## **PK22 Dimensions**

## New design compared to original design

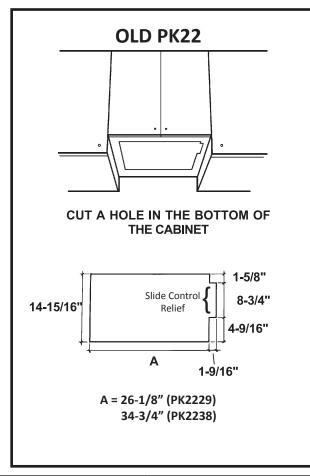
The **primary cut-out dimensions** are within 1/16" for depth and width (excluding the control cut-out on the old models). A new model has been introduced in 45" widths.

While the new model will fit into the cut-out opening of the old PK22, the cut-out may not be covered fully by the new PK22 face frame due to the relief for the slide control in the old model. Please plan accordingly to cover this area so it is not exposed.
